**SUBJECT: NRC AUGMENTED INSPECTION TEAM (AIT) REPORT 50-483/02-07 AND
PRELIMINARY WHITE FINDING - CALLAWAY PLANT**

Callaway Plant NRC Inspection Report 50-483/02-07

IR 05000483-02-07; on 01/28-02/27/2002; Union Electric Co; Callaway Plant. Augmented Inspection Report; Problem Identification and Resolution, Modifications. One preliminary White finding.

Figure 1
Auxiliary Feedwater System
Simplified Diagram

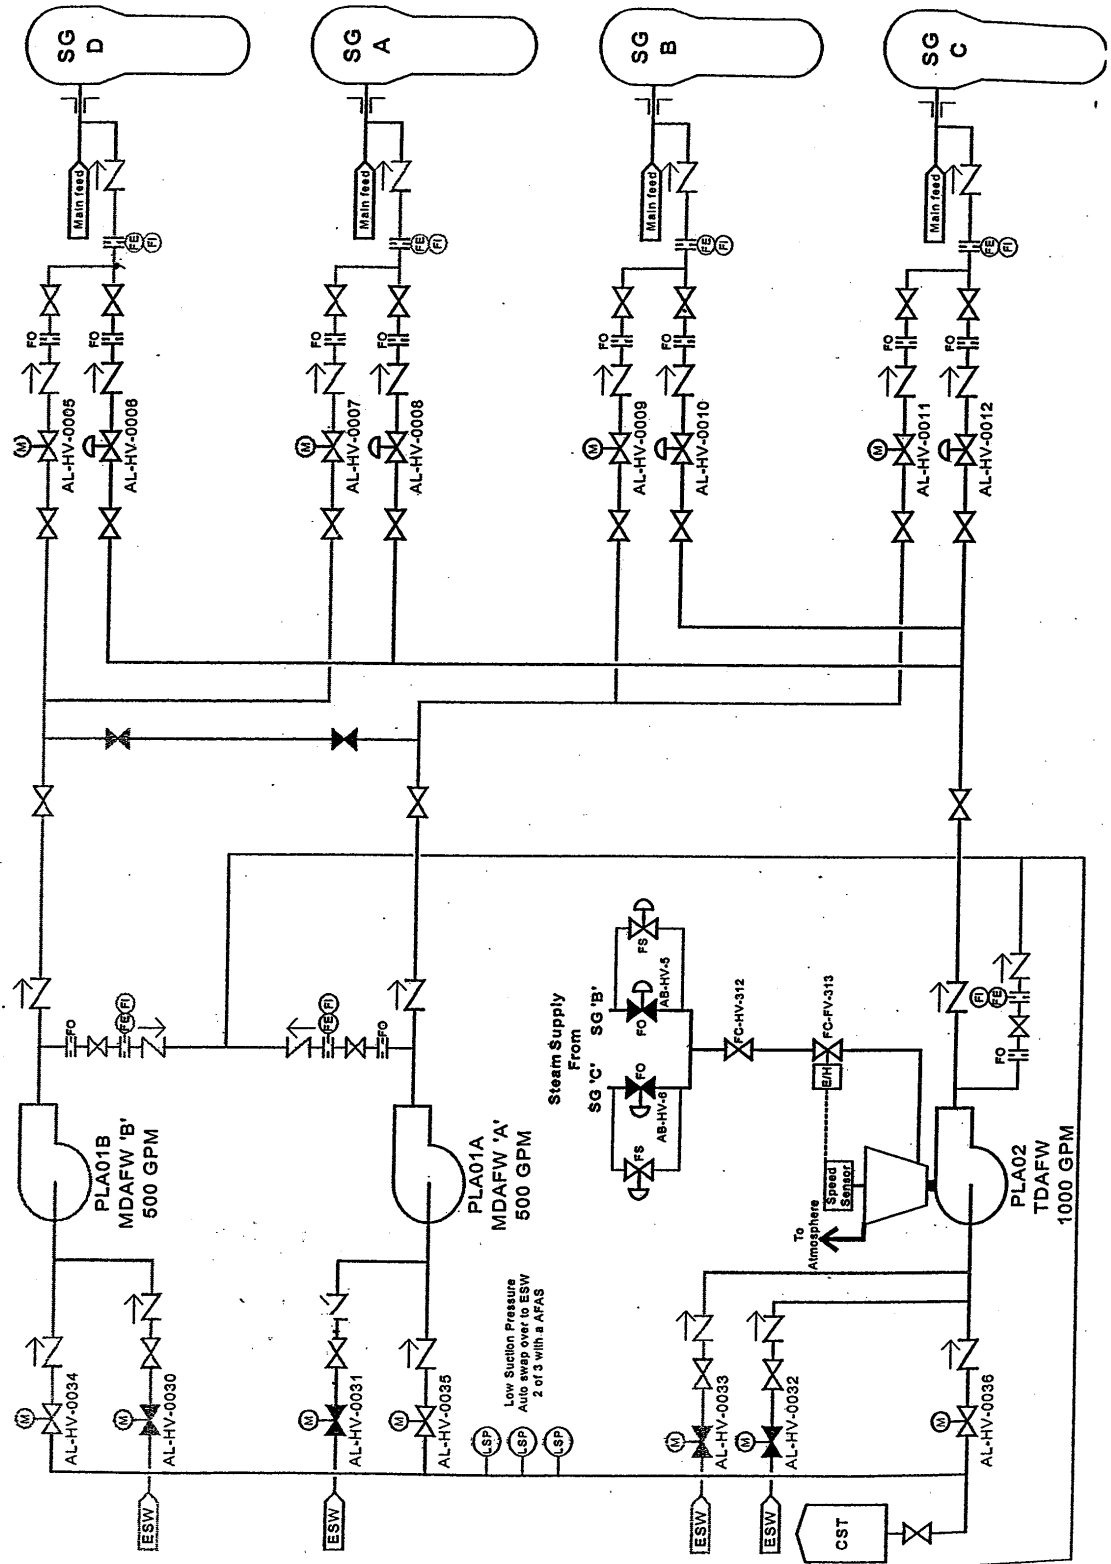
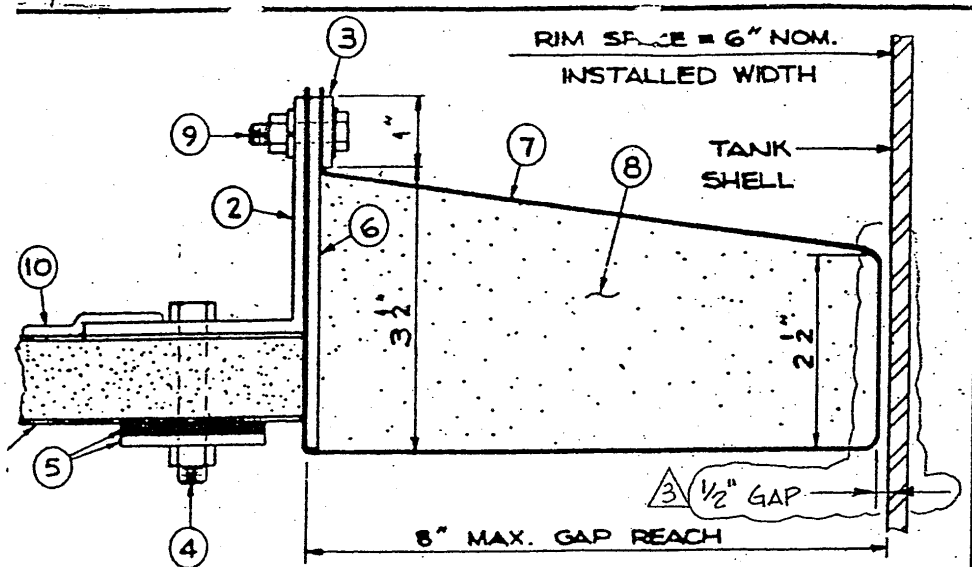
The auxiliary feedwater (AFW) system has 2 motor-driven pumps (A and B) and 1 turbine-driven pump. The pumps were normally aligned through a common suction line to the non-safety related condensate storage tank (CST). The essential service water system was credited as the safety-related source of make-up water to the steam generators. The AFW pump suction automatically switched from the CST to the essential service water system following a low level condition in the CST (See Figure 1).

Condensate Storage Tank
Diaphragm Seal

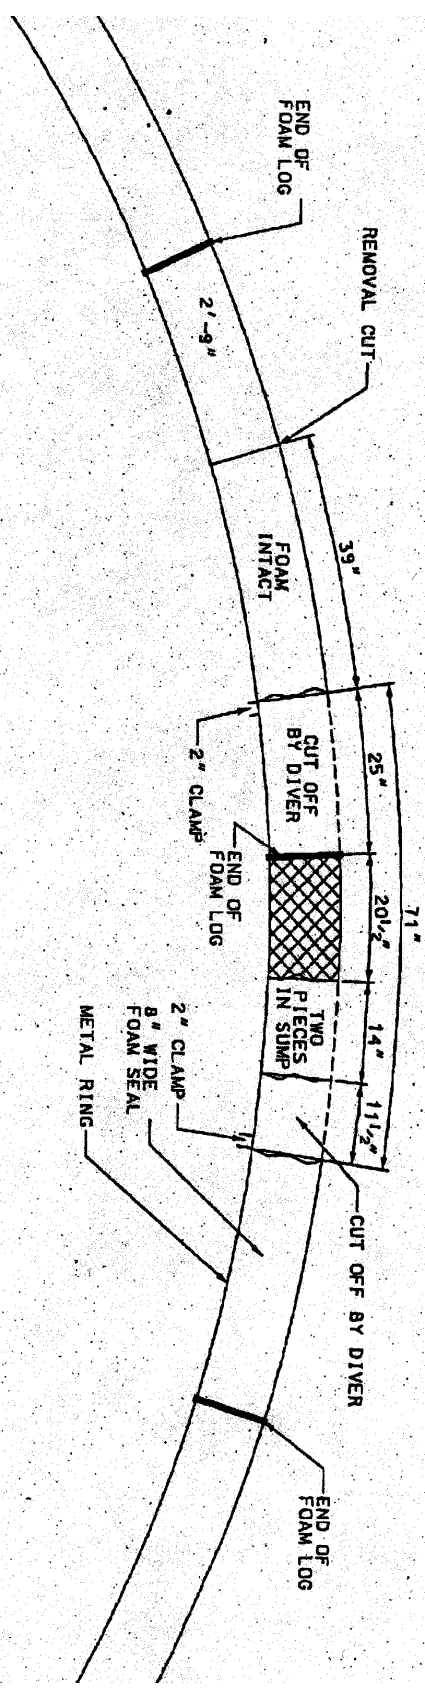
On January 26 and 27, 2002, the licensee found foreign material in the CST. The foreign material mainly consisted of pieces from the diaphragm seal assembly. The seal materials consisted of a Teflon-coated fiberglass fabric, flexible polyurethane foam, caulking material, and a piece of fiberglass (See Figure 2).

The team determined that the licensee's investigation of the CST diaphragm seal failure was of adequate scope and detail to conclude that the degraded Teflon-coated fabric and inner foam material was due to constant nitrogen sparging of the CST at 5 standard cubic feet per minute. The nitrogen bubbles from the sparging impinged on the diaphragm seal and increased the wear on a 6-foot section of the approximately 130-foot circumference. The licensee calculated that the impact forces were on the magnitude of 0.02-lb force on each square inch of the lower surface of the seal at a rate of approximately 68,700 cycles per impact site over a 4.5-year period. Once the Teflon coating failed, the same mechanism acted directly on the foam. This failure mechanism continued to occur until sections of foam became detached and settled on the bottom of the tank.

Condensate Storage Tank Configuration

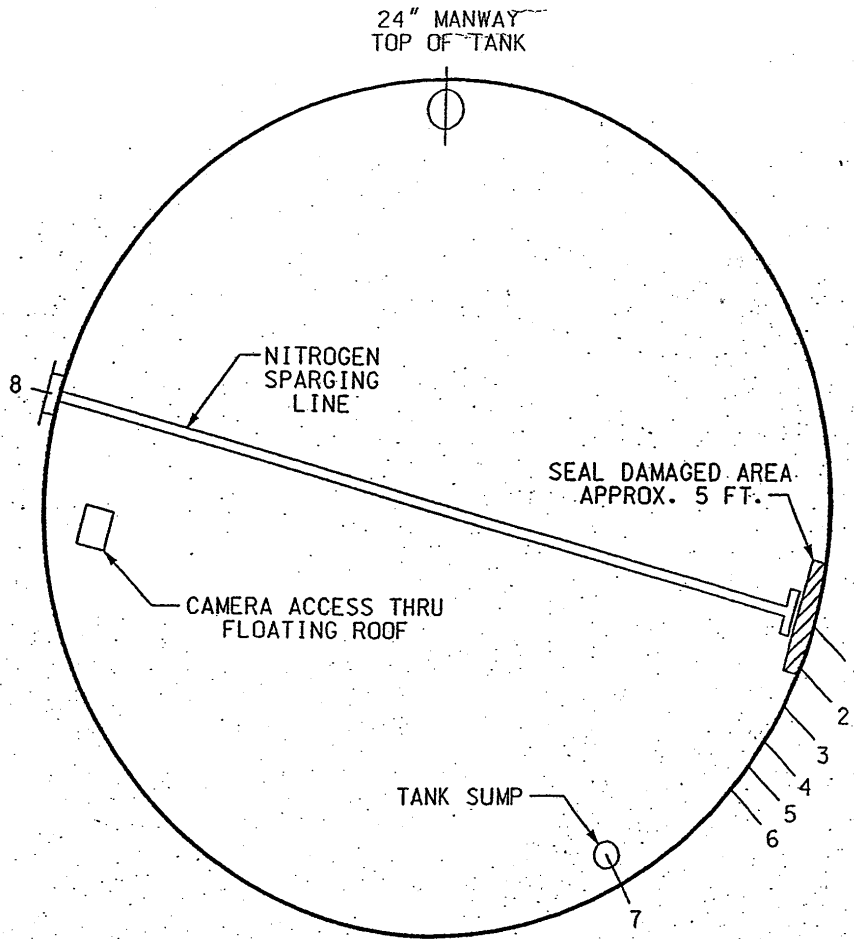
The team determined that the degradation of the seal was limited to a 71-inch circumferential section of the diaphragm. The degraded portion of the diaphragm seal was located above the single suction source of the AFW system (See Figure 4). The following table provides a listing of the missing foam portions of the seal.
